MEMORANDUM

SUBJECT: EPA Comments on draft “Assessment of Dam Safety of Coal Combustion Surface Impoundments: Gainesville Regional Utilities Deerhaven”

DATE: September 19, 2013

project **76-077-1**
 contract **29C-YARD STRUCTURES III**
SK-077-29C-3

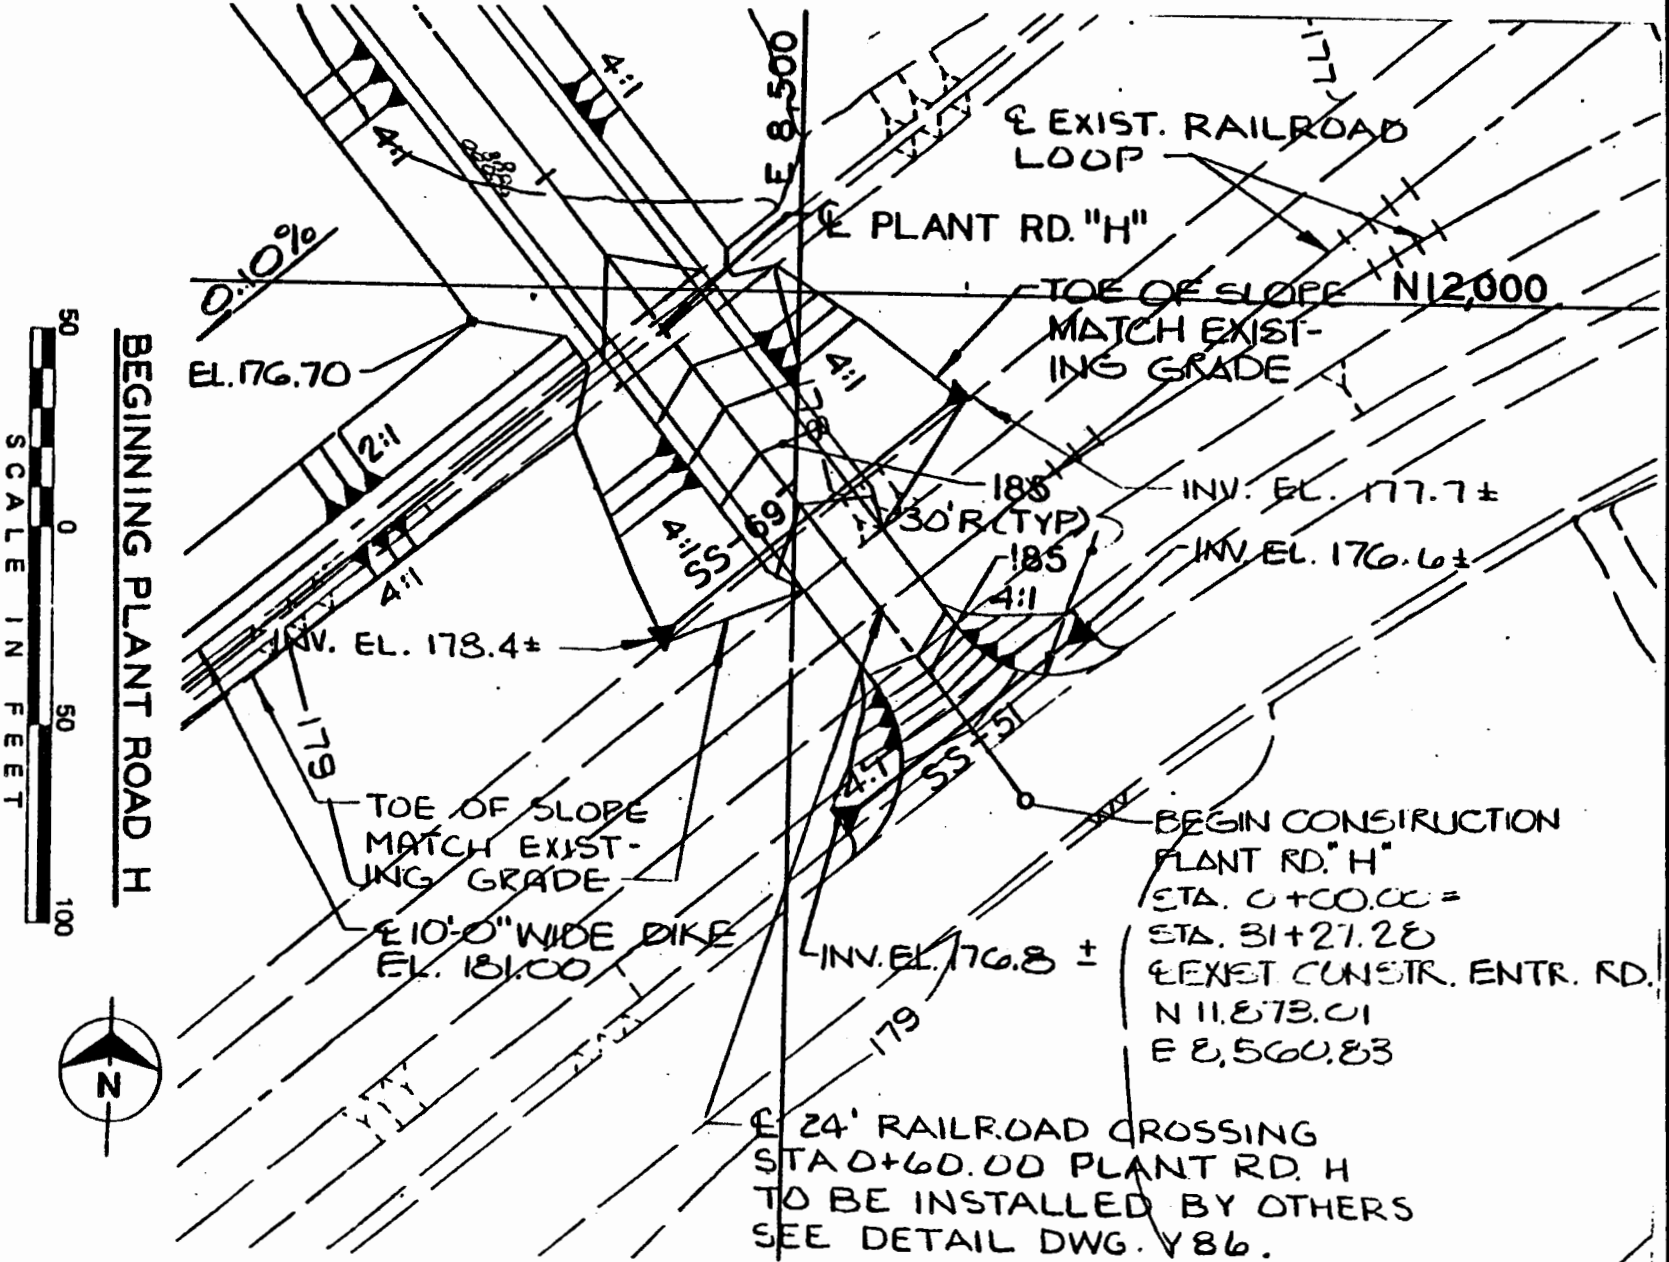
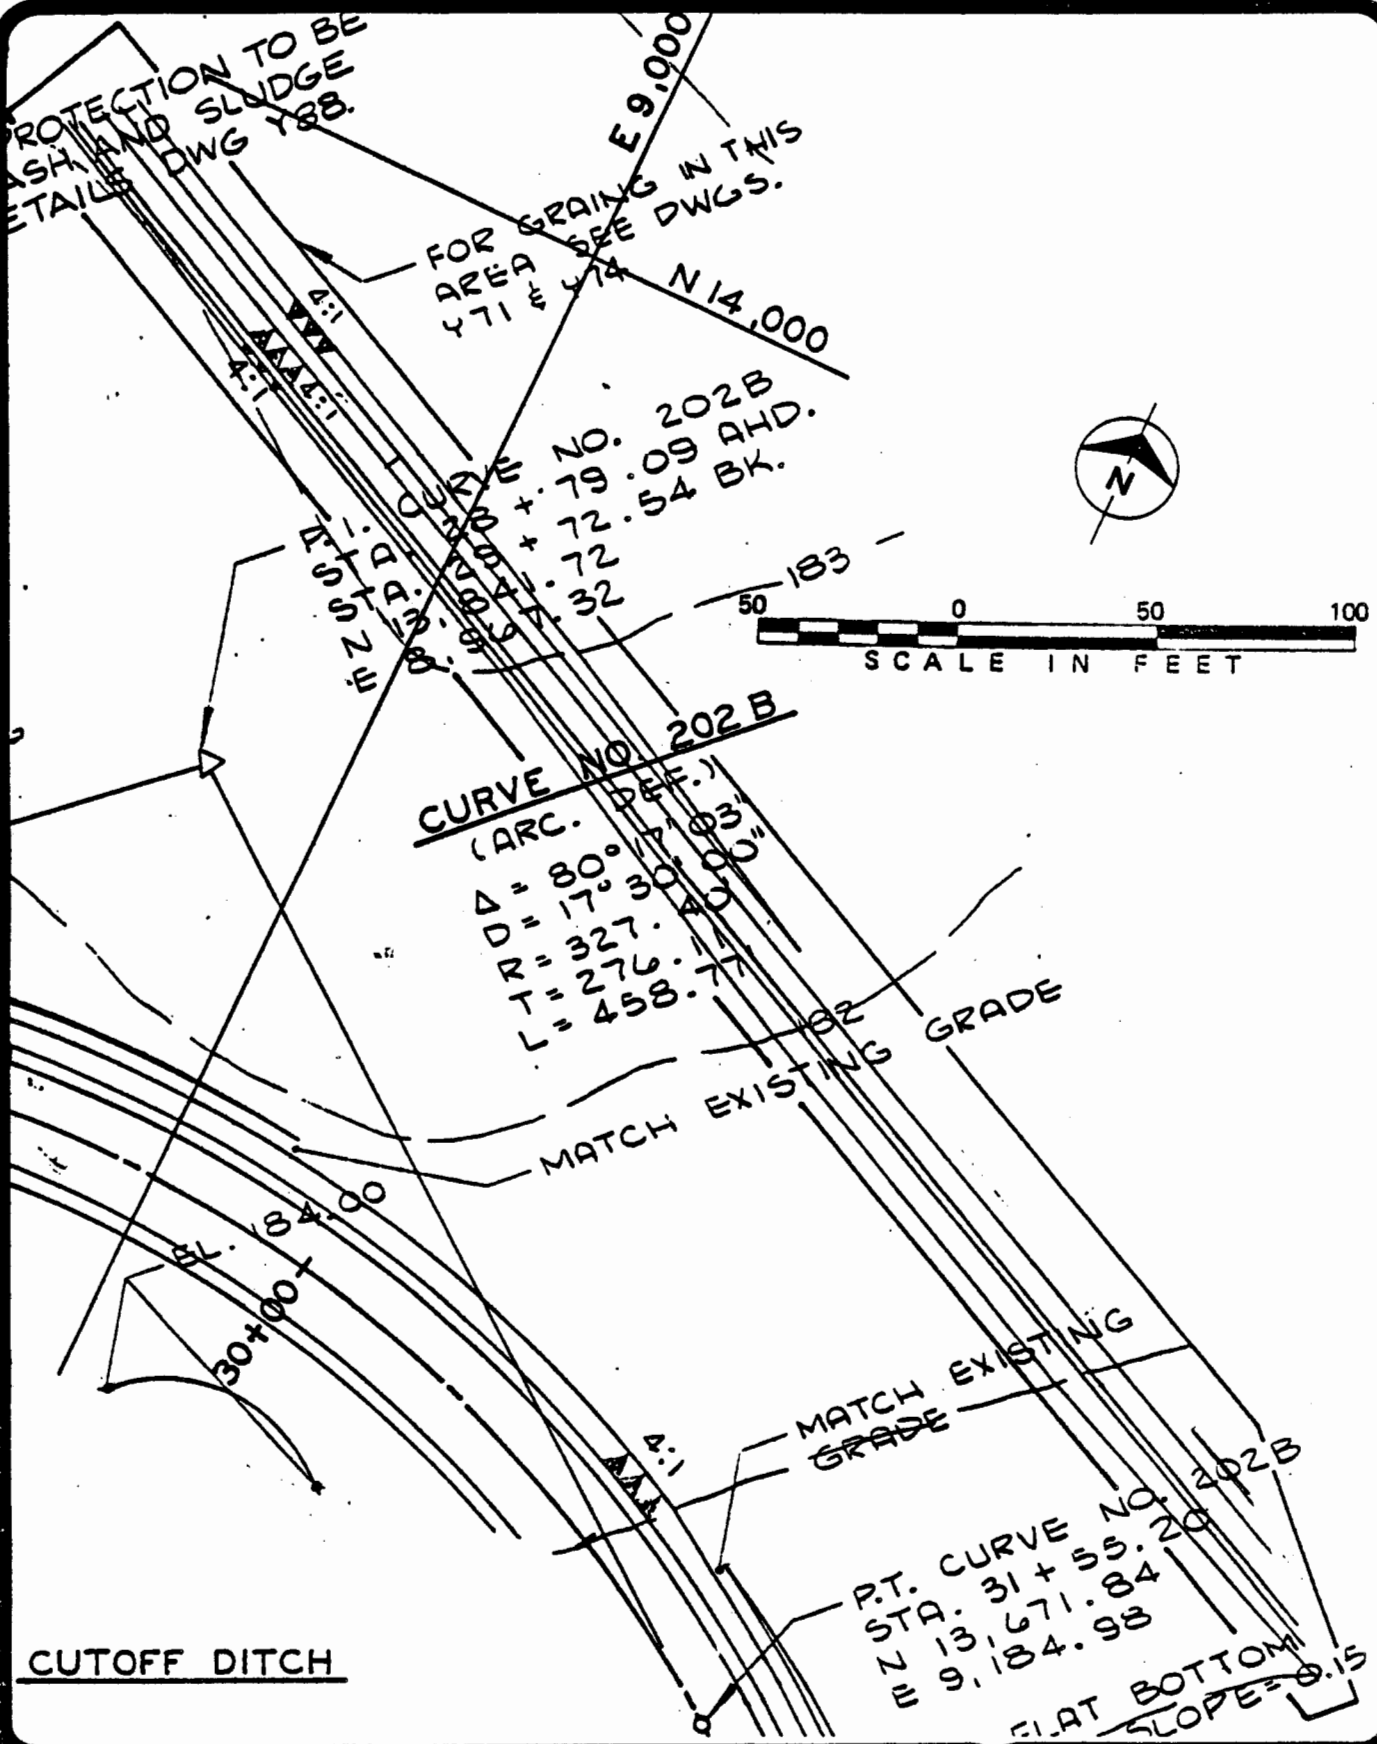
- e. Revise "Isometric of Scupper" and "Scupper Detail" per sketch no. SK-077-29C-8.
5. DRAWING A87:
 - a. Indicate "screen" to be galvanized in detail of "Fan in Masonry Wall."
